# STATE HIGHWAY 105 / JACKSON CREEK PARKWAY - PHASE 2

## CONSTRUCTION PLANS

FEBRUARY 2023

(PBS-R/L = PED PUSH BUTTON STATION WITH R10-3e RIGHT OR LEFT SIGN)

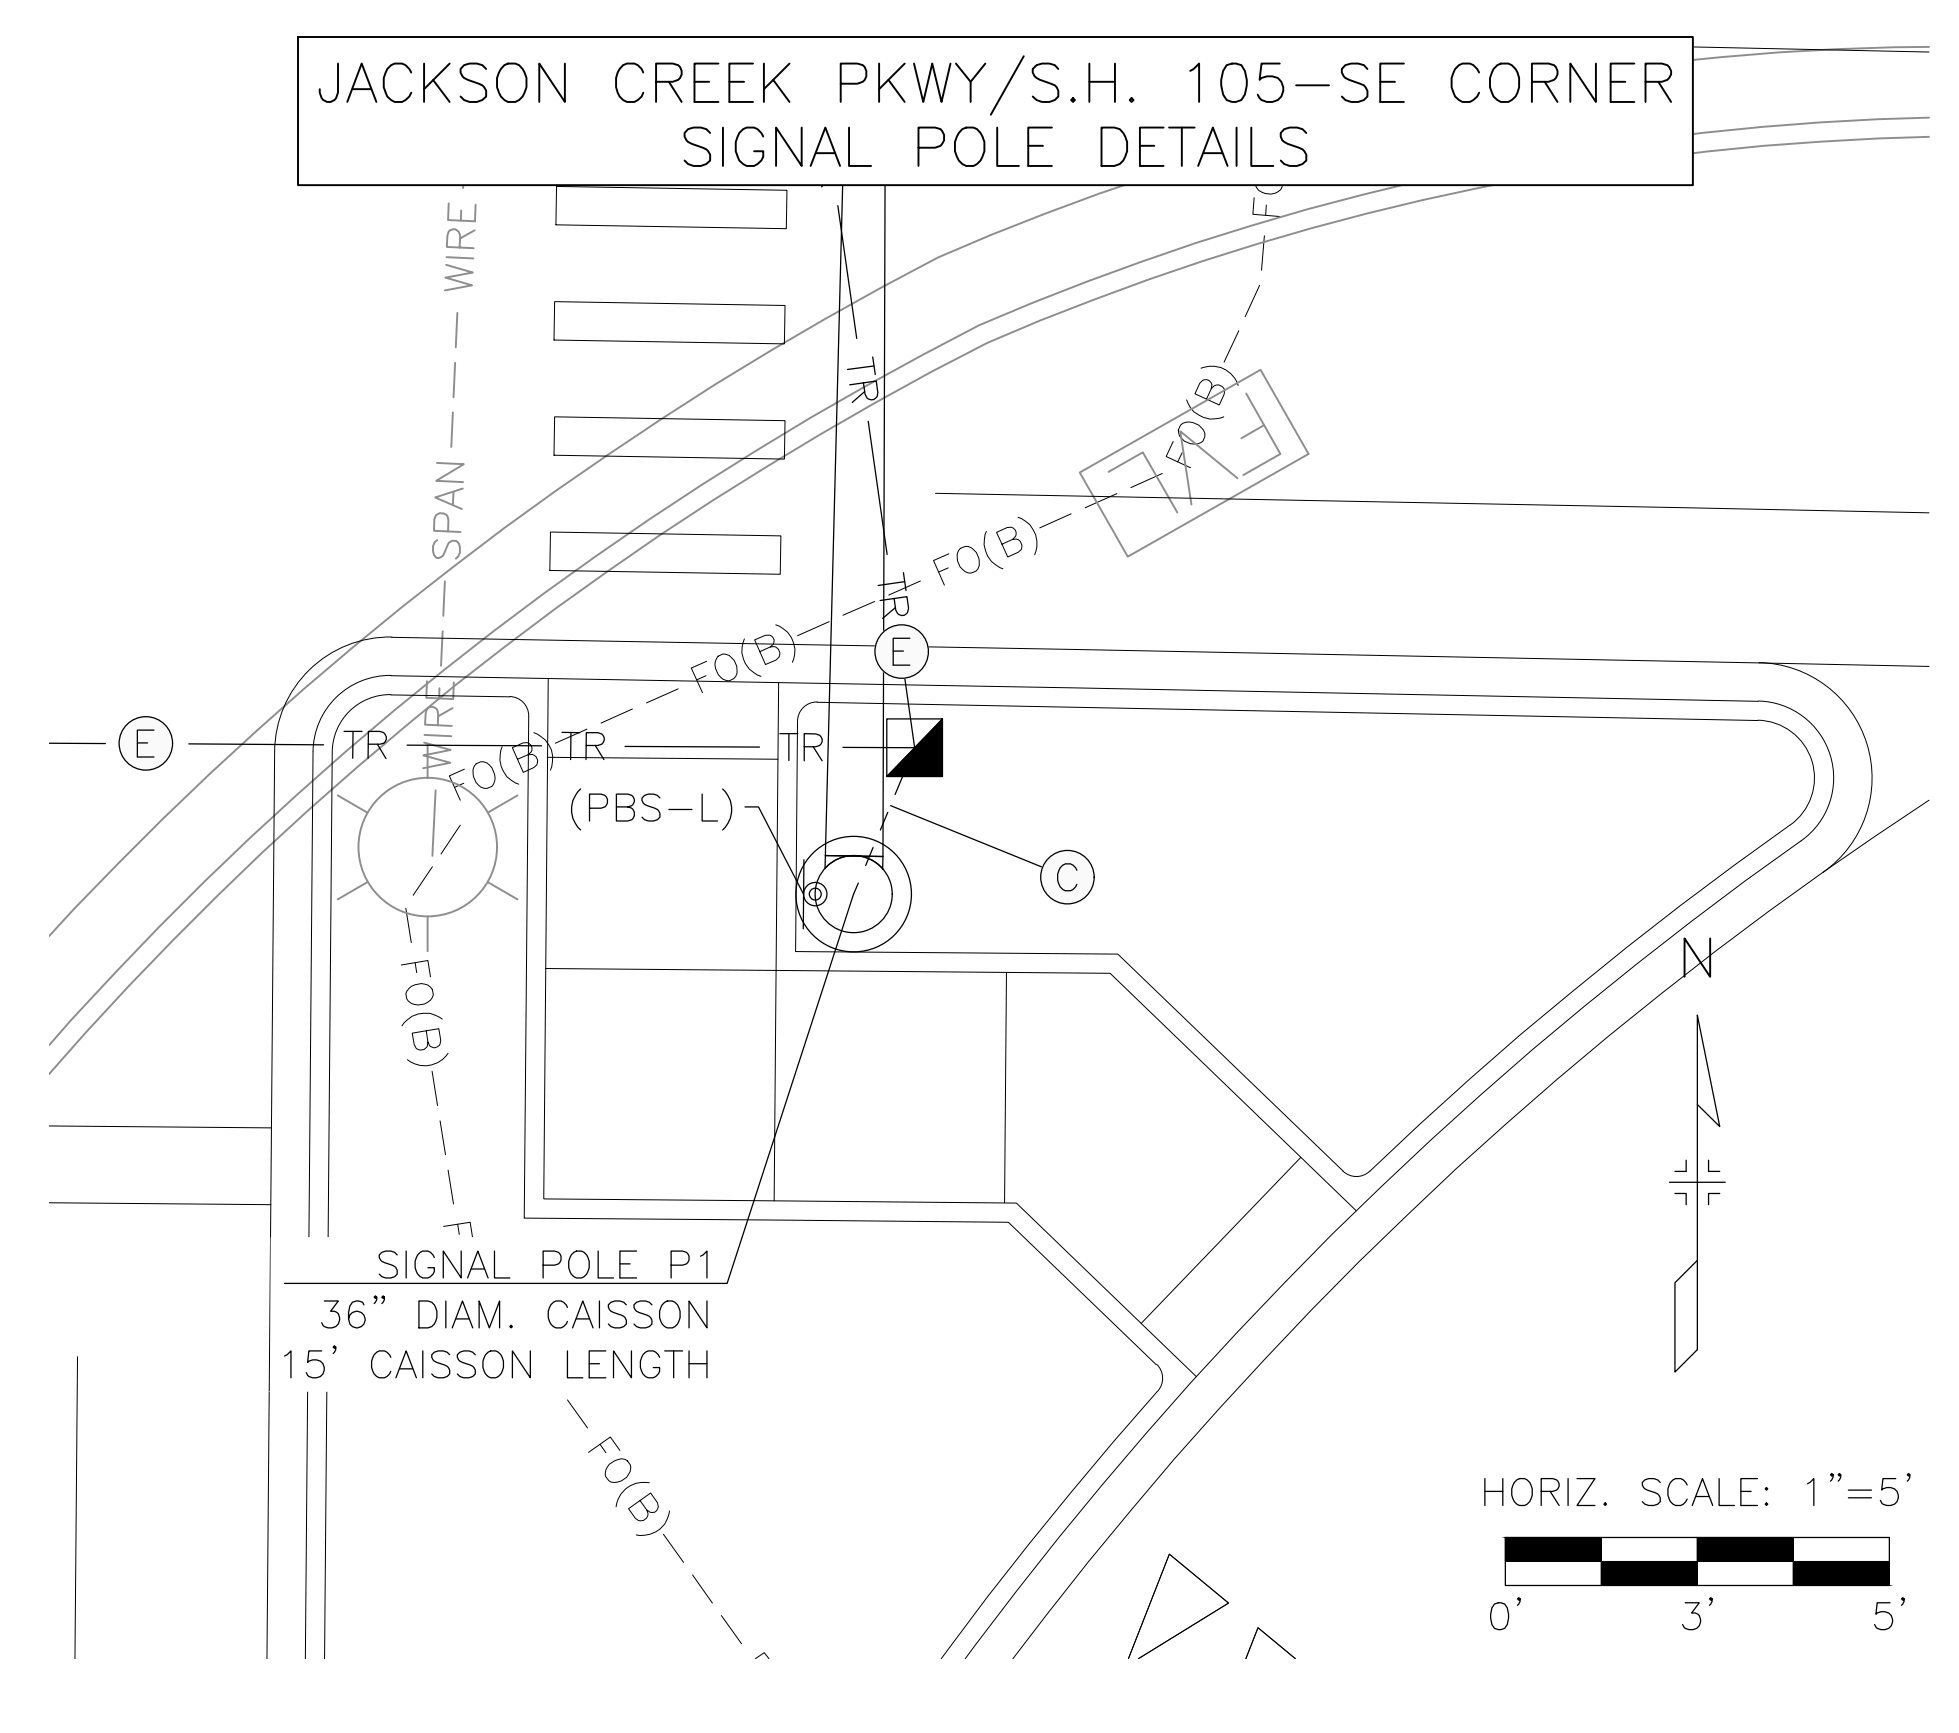
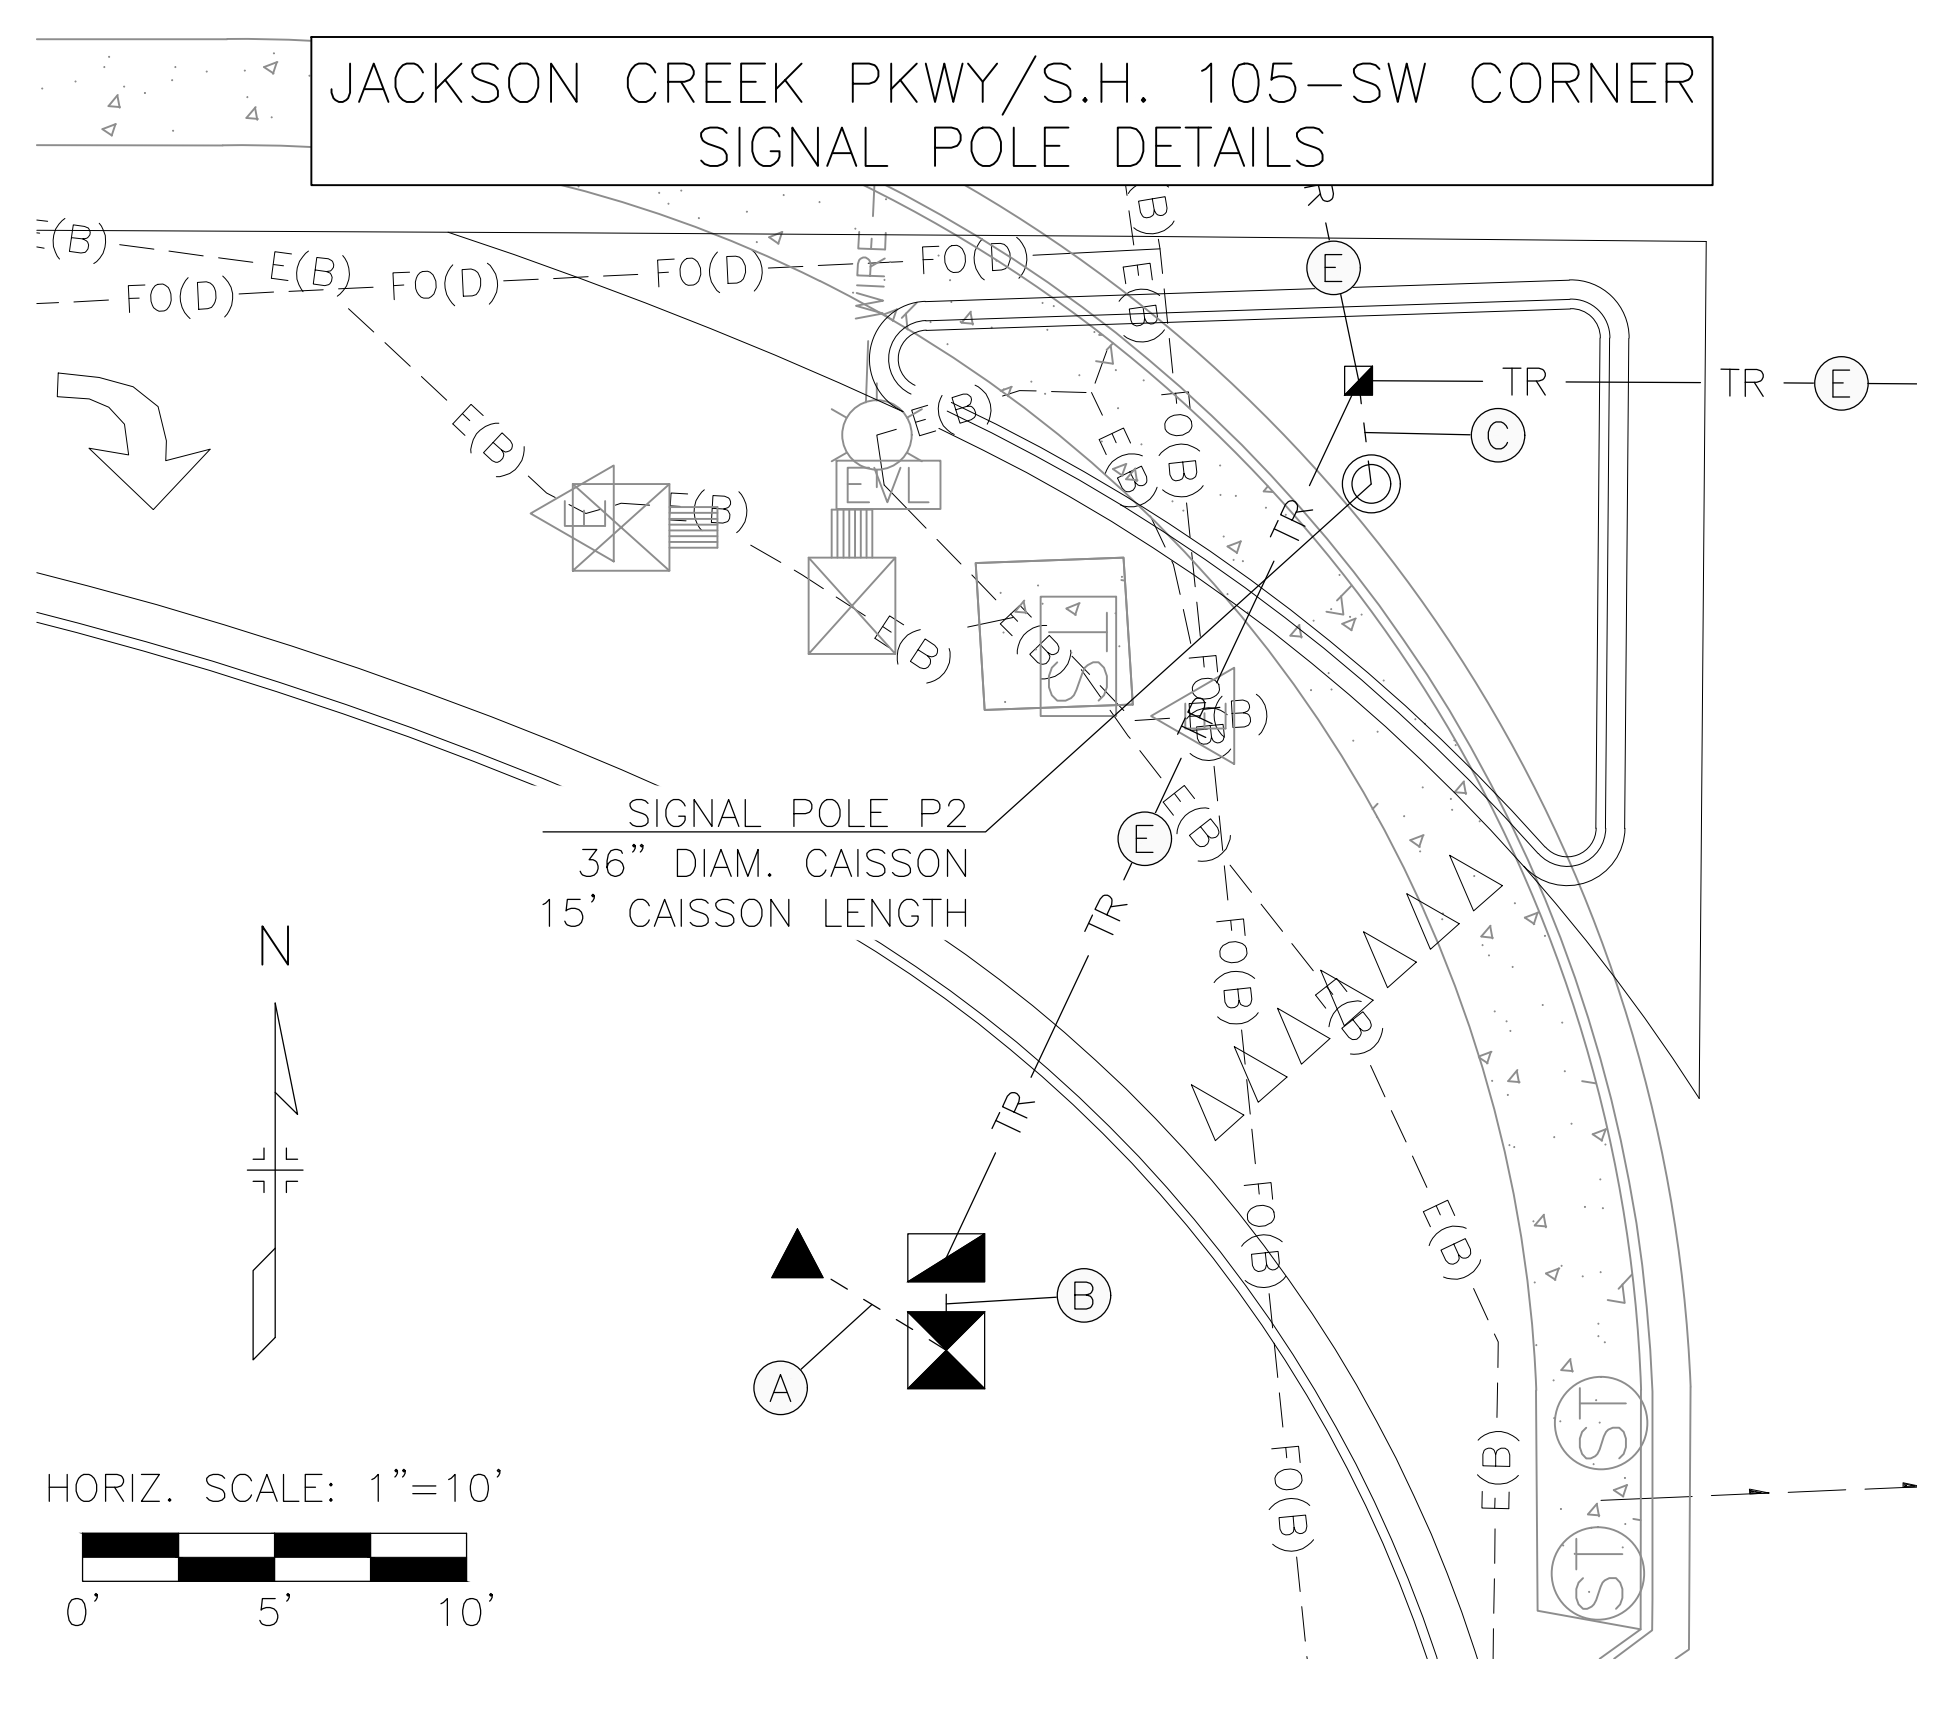
Suggest the curb ramp design provides provide way more details. elevations, slopes, placement of ramp along the face of the islands. I don't think these are easily buildable in the field.
